1991 - 1992 Corvette: Service Bulletin: Starter Inoperative/Clicks/No Start

Model and Year: 1991-92 Corvette with Automatic Transmission

Bulletin Number: 92-322-6D

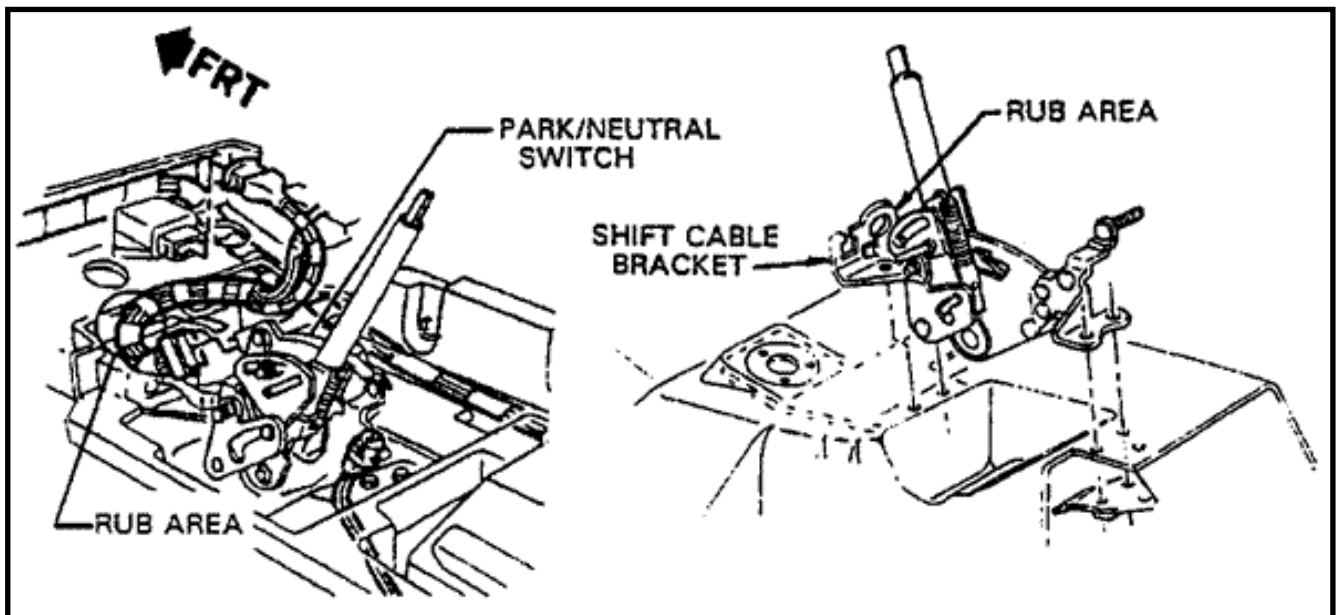
The 10 gauge purple wire from the park/neutral switch in the console is rubbing against the shift bracket (see illustration). This causes high resistance in the circuit, resulting in low voltage to the starter.

1. Disconnect negative battery cable.
2. Remove console trim plate as shown in the 1992 Y Car Service Manual, page 8C-11.
3. Check the wire harness in the area shown in the illustration for signs of rubbing. Correct as necessary.

4. Reroute the harness to the right of the bracket, about 50 mm (2 inches) over, and under the plastic portion of the console. Secure as needed to insure that the harness cannot contact the bracket
